**HONDA ServiceNews**

ASN 21521 (0003)

62. Center Panel (EX)

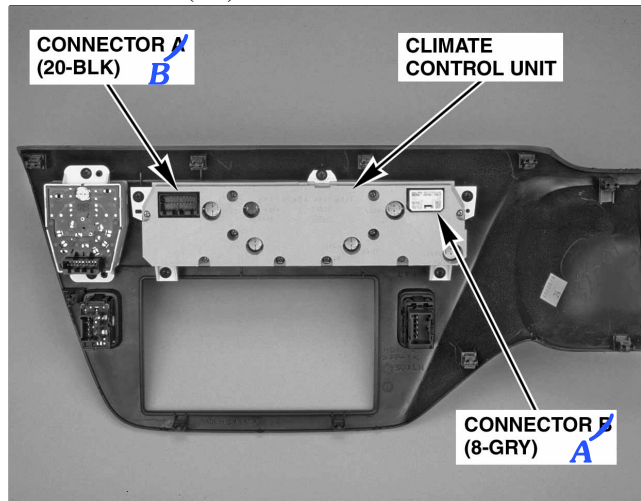
On page 201-10 of the '99-00 Odyssey ETM, photo 62 has the connector names for the climate control unit reversed. (The gray, 8P should be connector A, and the black, 20P should be connector B.) Here's how to mark up your manual.

S/M Fix: Accord Tie Rod Nut Torque

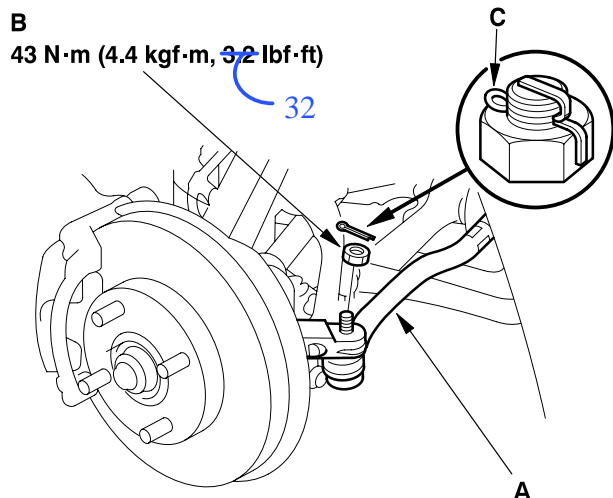
On page 17-49 of the '98–00 Accord S/M, step 14 of steering gearbox installation lists an incorrect torque for the tie rod nut. The torque should be 43 N·m (4.4 kgf·m, 32 lbf·ft). Mark up your S/M like this:
